To: Prowest
Job: Horace Mann New Classroom Building
COR # 20
RE: IB # 026
Scope: To raise the parapet wall 2'-0" around the Gym and to add walls from 15' to 18' which includes framing sheathing and plaster per Instruction Bulletin # 026.

INSTRUCTION BULLETIN: 026

PROJECT:
 HORACE MANN NEW CR
 WING AND UNDERGROUND
 PARKING

Change Proposal Request #073

RELOCATED Elevator Machine RM
FANC COIL (FC-5) to First FL
Storage B153 (DSA Deferred
Submittal #137 (Otis Elevator)

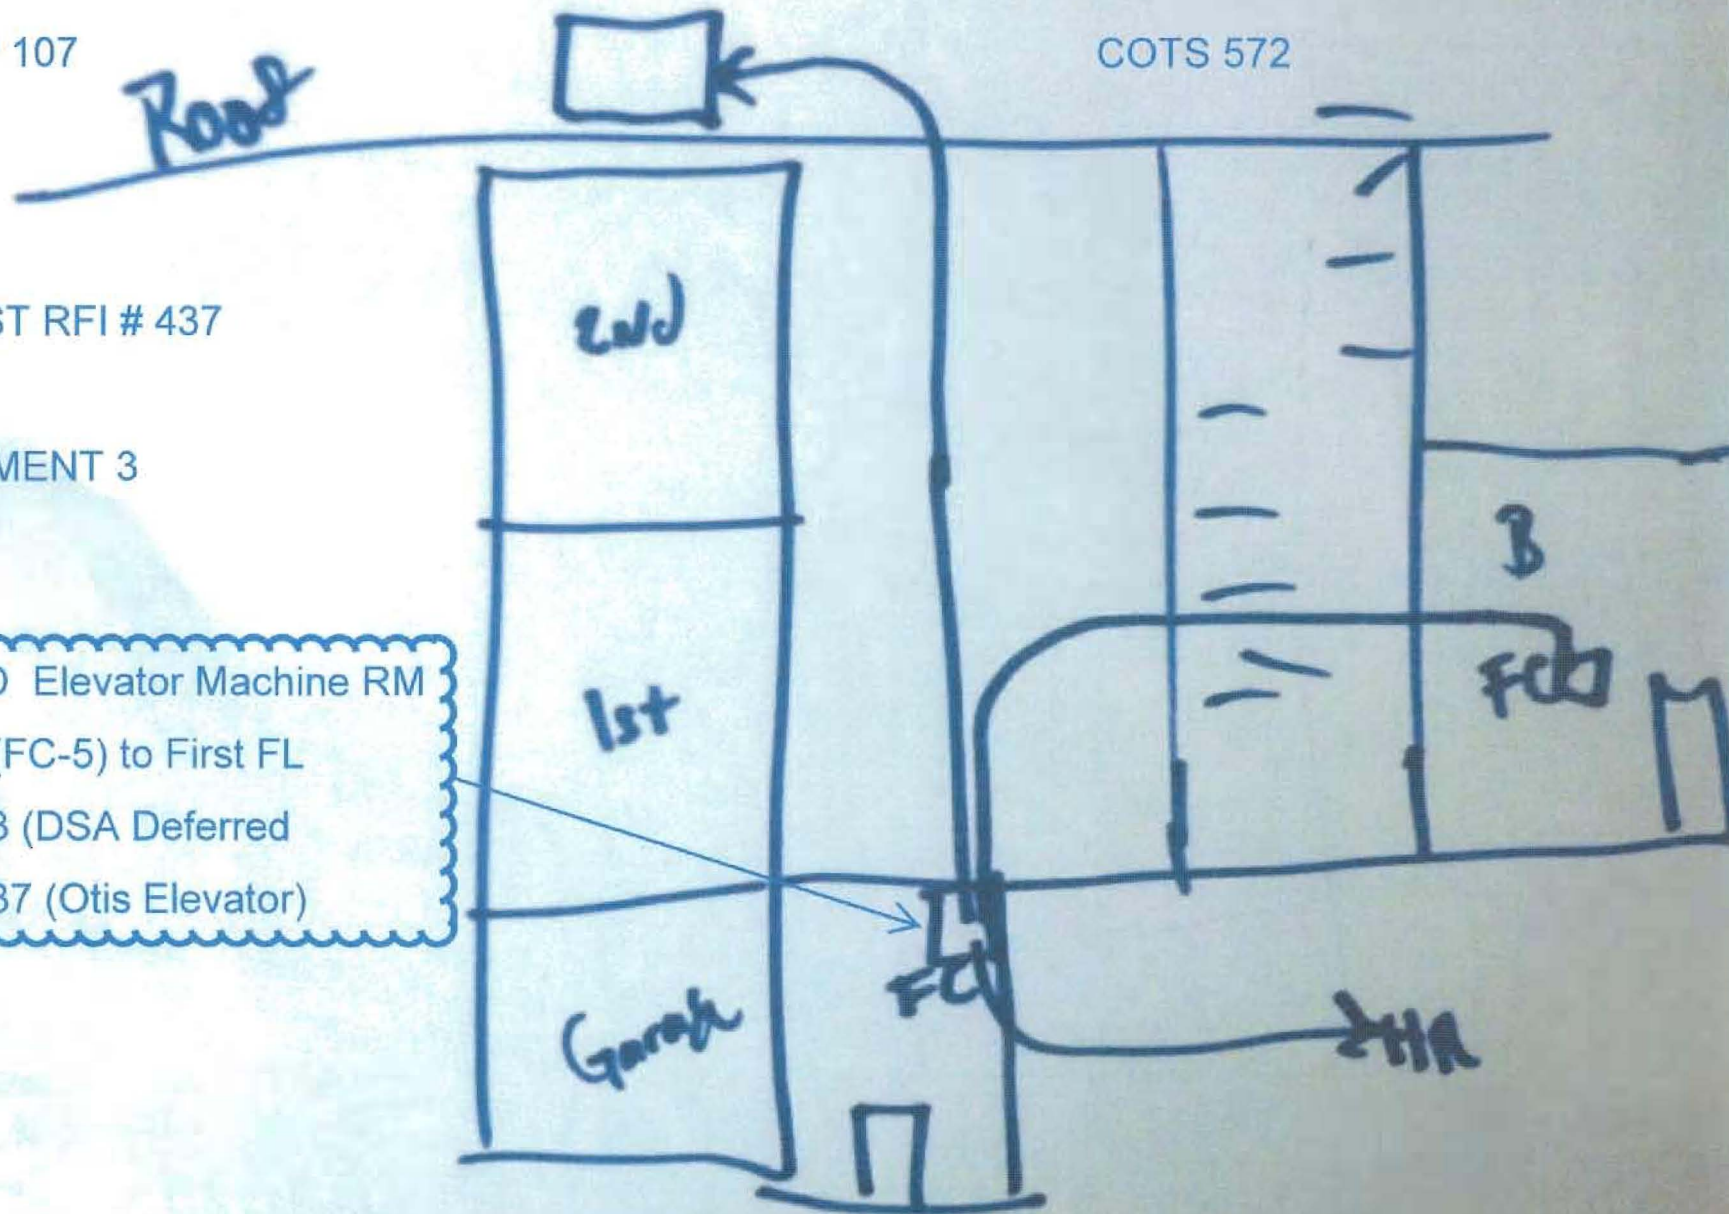
Due to the relocated Elevator B182 Machine RM (Submittal #137); which had planned location at Basement FL, adjacent to Hall RM B001 (Attachment 1); to the new location on First FL Storage B153 (DSA Deferred Submittal #137 (Otis Elevator) - Attachment 2.; are proceeding with relocating the electrical & mechanical systems to accommodate elevator gear & equipment (Attachment 3). Our mechanical sub (Air Flow) is proposing to relocate Fan Coil Unit (FC-5) to match the installation of Fan Coil Units (FC 1-4) Wall Mounted Units (Attachment 3). This Basement FL Fan Coil Unit (FC-5) is a ducted fan coil; while Fan Coil Units (FC 1-4) are wall mounted, ductless units. Is it acceptable to switch FC-5 to a ductless fan coil, matching the same model for units FC 1-4, due to Elevator Machine RM relocation to First FL Storage RM B153, noted on the approved Submittal #137? Please advise.

Change Fan Coil Unit FC-5 to ductless unit (match FC 1-4 TYP); and install to the new location on First FL Storage B153 (DSA Deferred Submittal #137 (Otis Elevator).

PROWEST Constructors
RFI #329
08-06-15
ATTACHEMENT 2

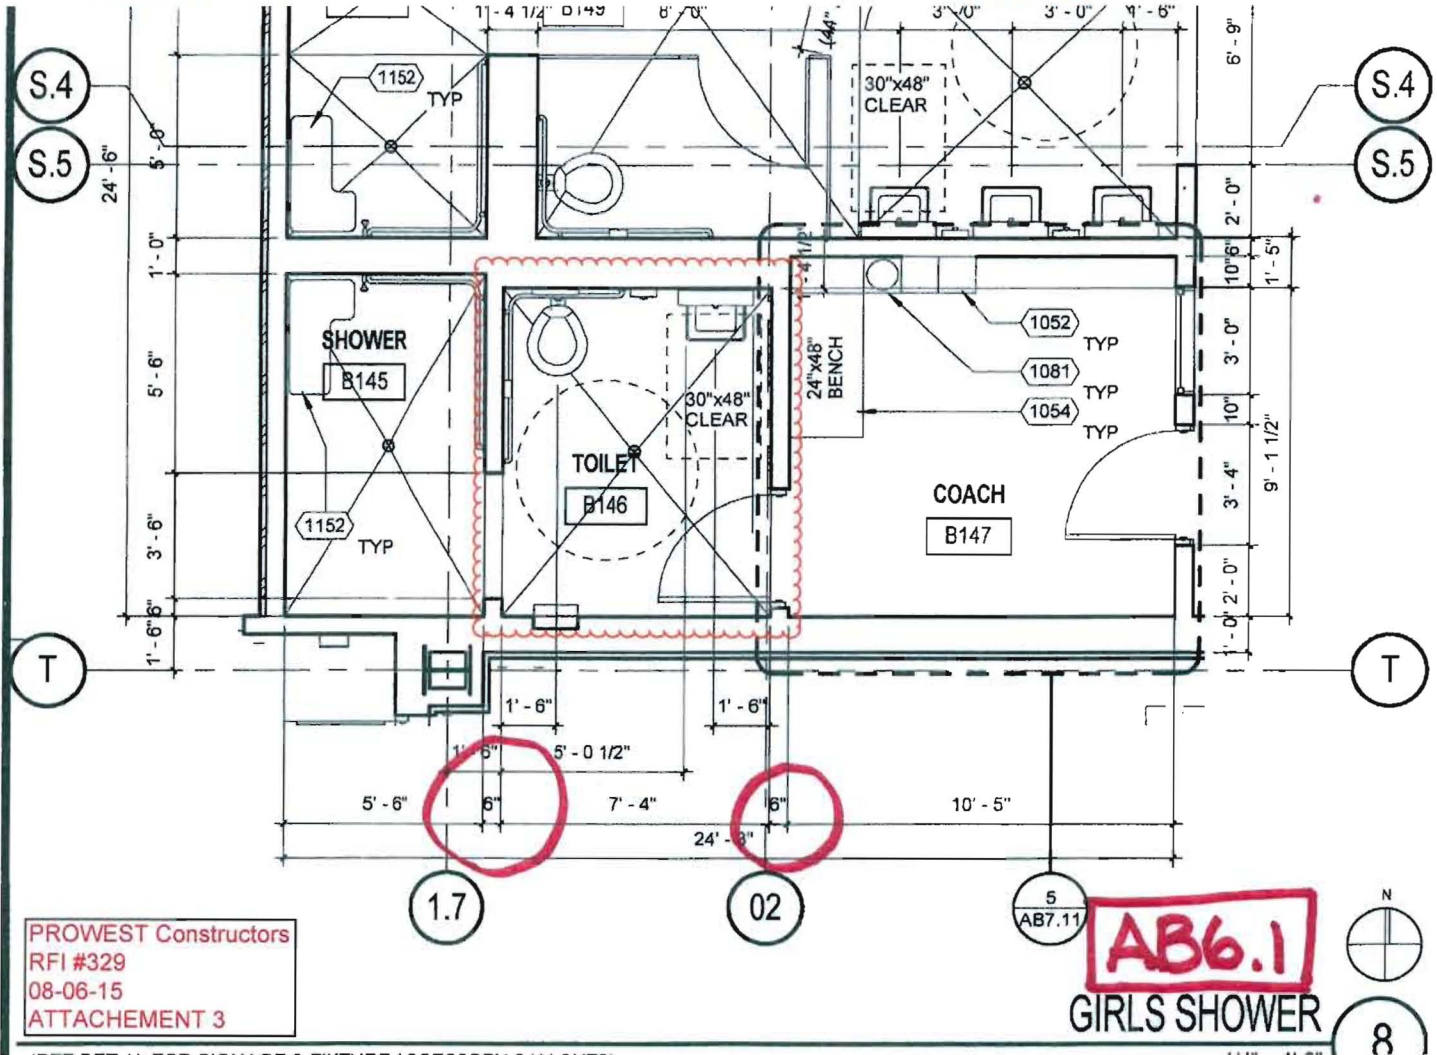
There is a Typical Notes conflict between floor plans and enlarged floor plans. Typical note on architectural floor plans (i.e. Note 3 on AB2.5 - Attachment 1) reads: "dimensions for studs are from face of stud interior studs or face of exterior studs." Typical note on the enlarged floor plans (i.e. note 5 on AB6.1 - Attachment 2) reads: "all dimensions are to face of finish." To maintain ADA clearances, the interior walls in the applicable areas at First FL Shower RM B145 and Toilet RM B146 at Gridline T; Lines 01 & 2.7, need to be changed to 4 inch studs (i.e. 8/AB6.1 - Attachment # 3). Please confirm this is acceptable?

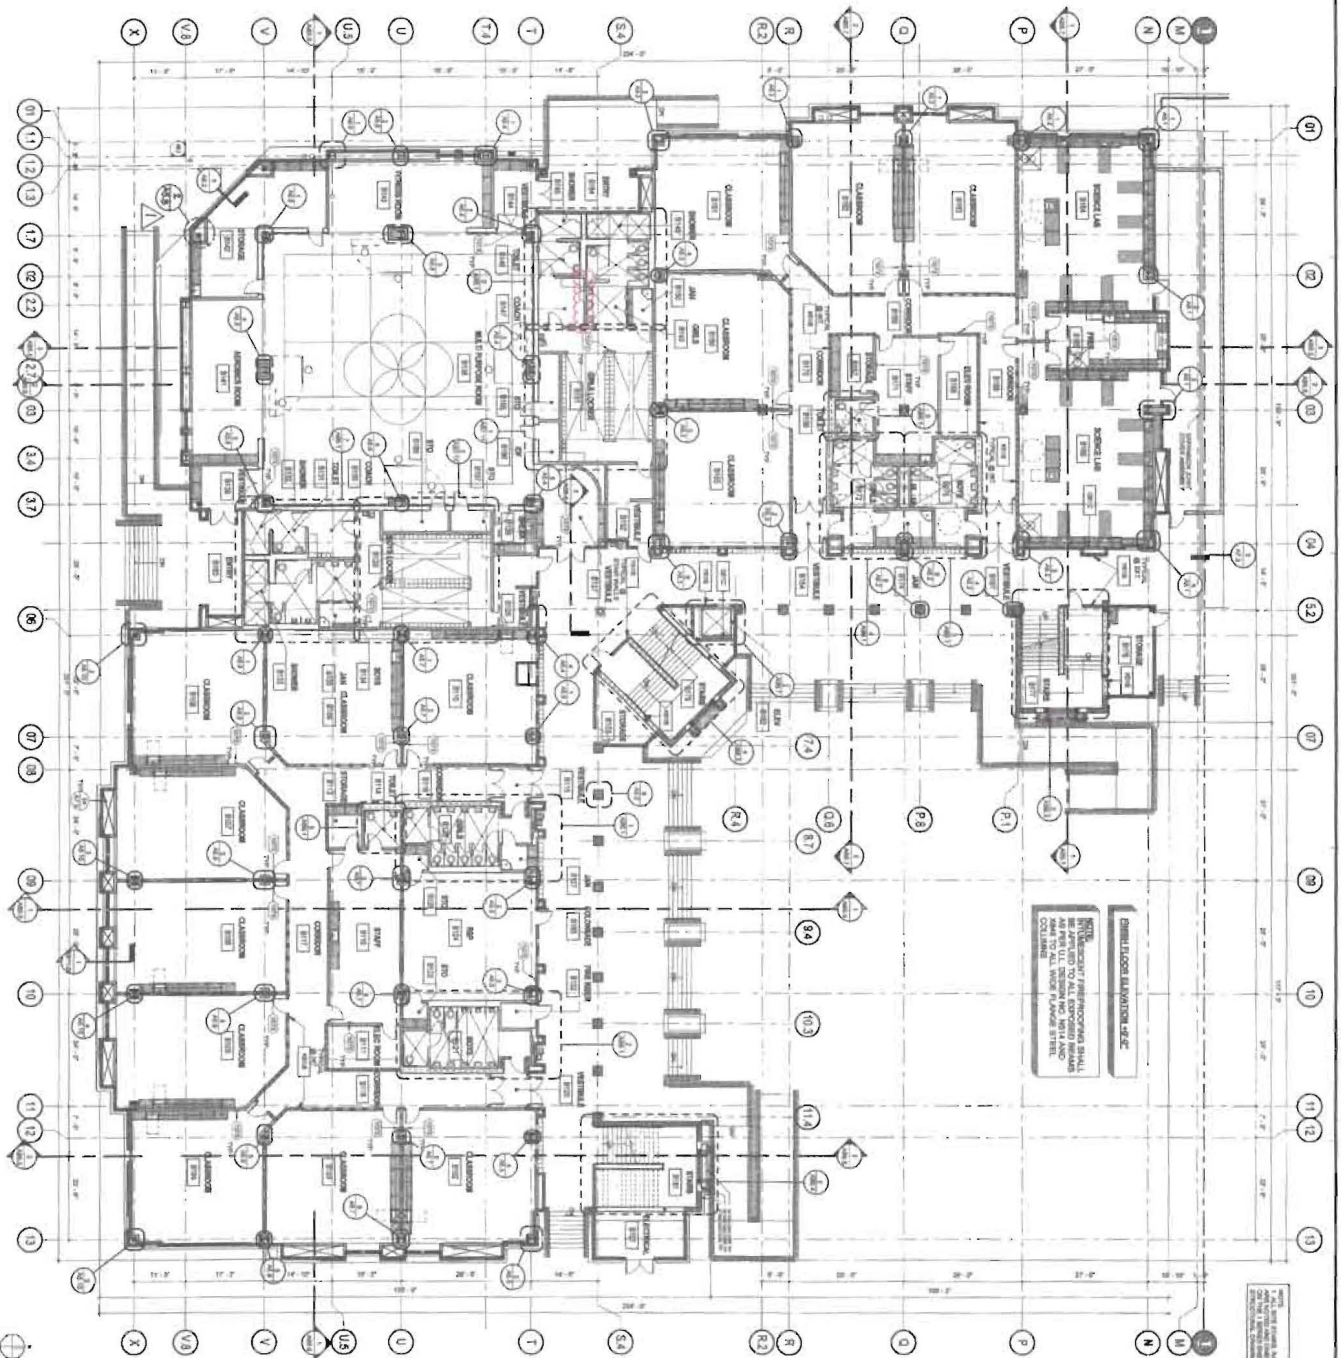
The Architectural Detail AB2.3 for Girl's Shower (Coach RM B147), blow up Detail 8/AB6.1 (Note # 5: "All dimensions are finish to finish"), and per RFI# 329 response "to use 4in studs to maintain ADA & finishes, as needed", the wall north of Coaches Office B147 is called out as a total width of 6in. After talking to our Plumbing Sub, wall needs to remain as a 6in metal stud wall due to being a plumbing chase wall, which means we now are going to be shy 1in of finished on each side of this wall. Is this acceptable? Advise.

Per RFI 329.2: Wall moved 1/2" North. Use 6" Stud at Coach Office, North Wall only. Coach Office will be 1-1/2" Narrow.

GIRLS SHOWER

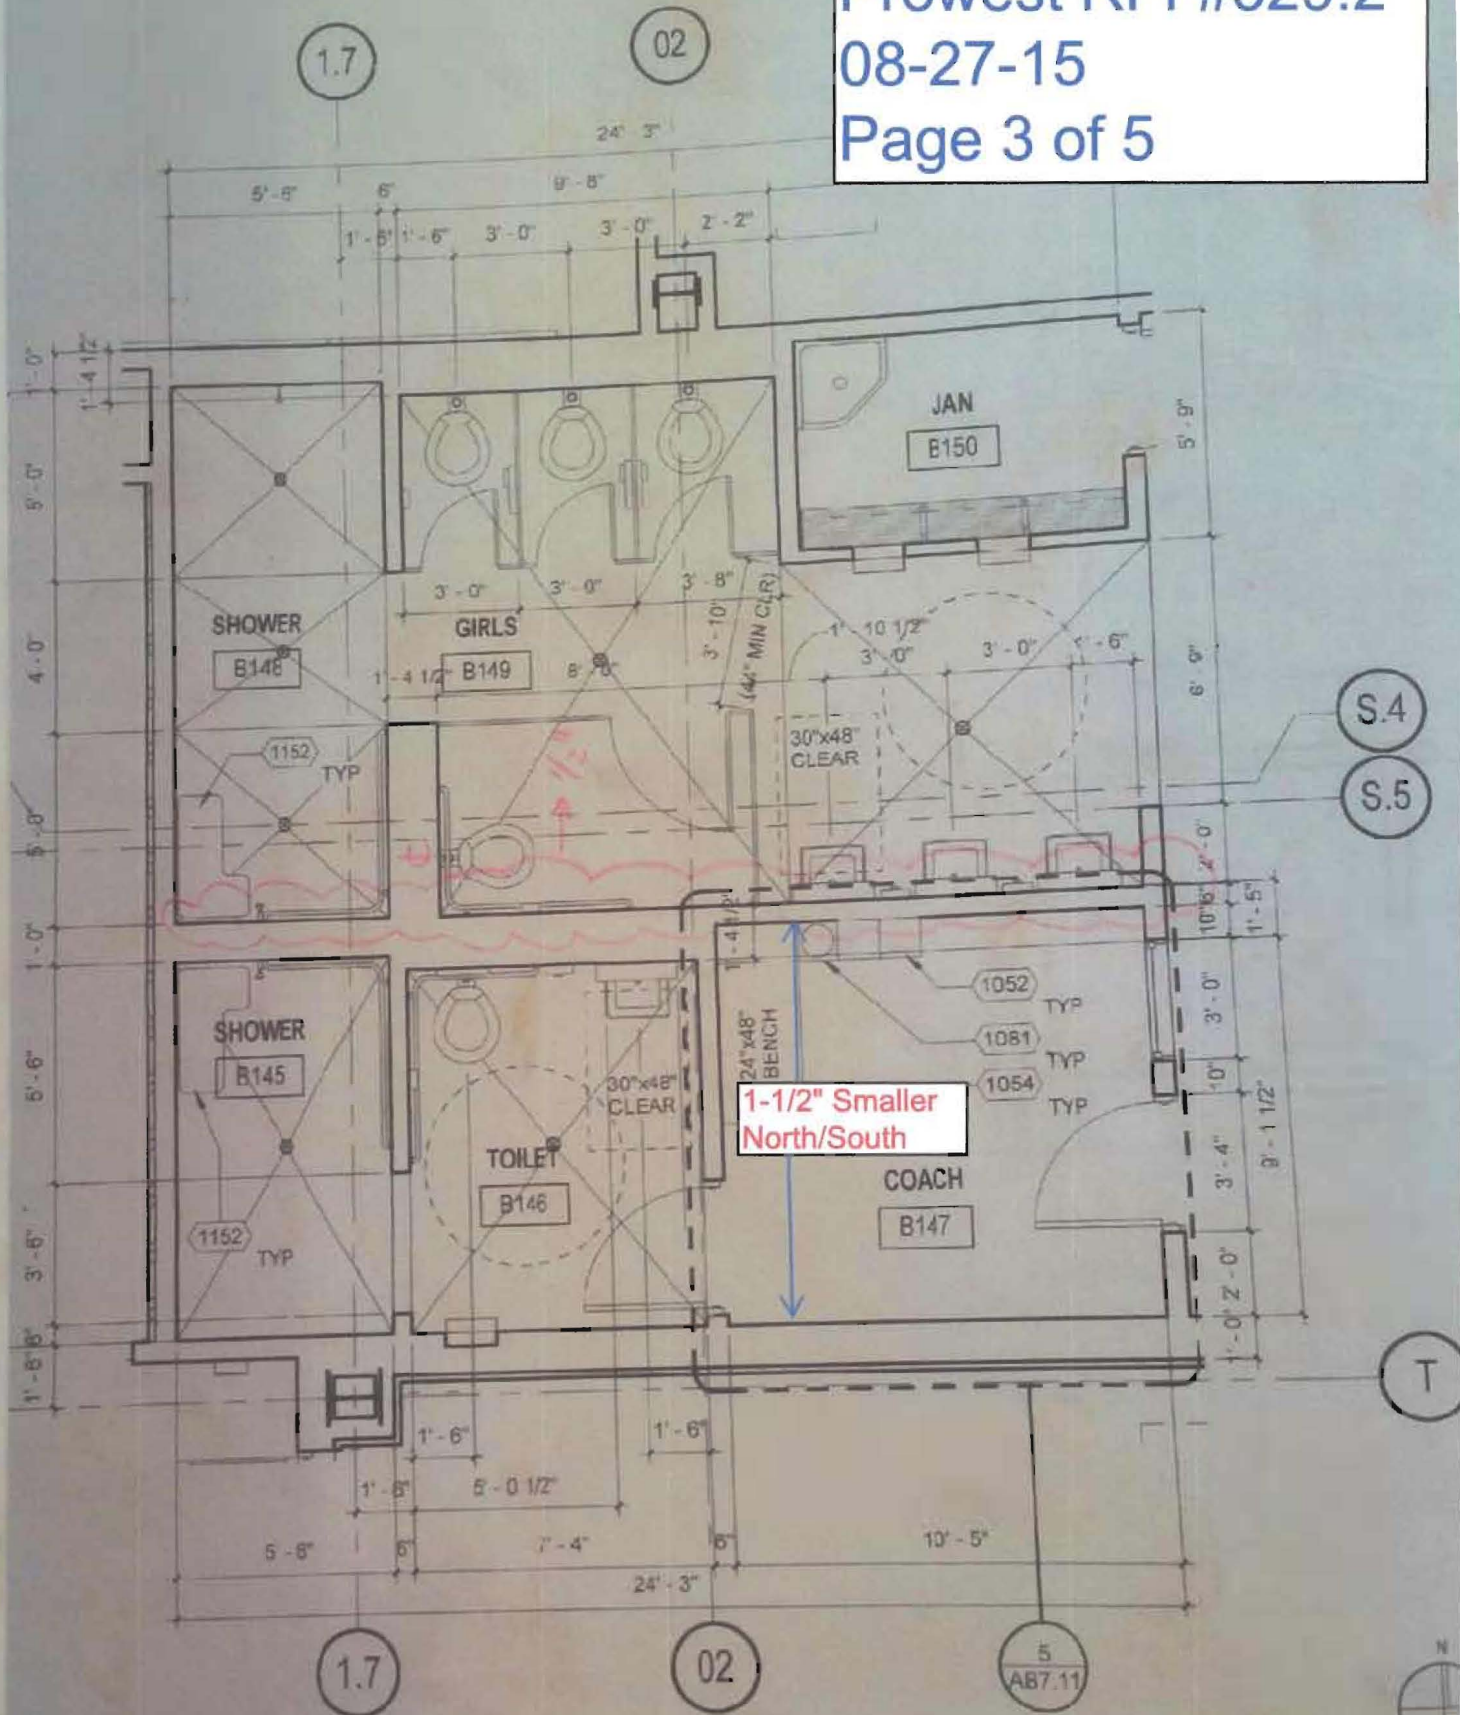
Per Girl's Shower blow up detail 8/AB6.1, the plumbers toilet carrier is embedded in concrete and in order to maintain ADA dimensions from center of carrier over to finish wall, the wall partition south of carrier will have to move 1/2" north, wall aligns from end to end. *See attached drawing. Is this acceptable? Advise.
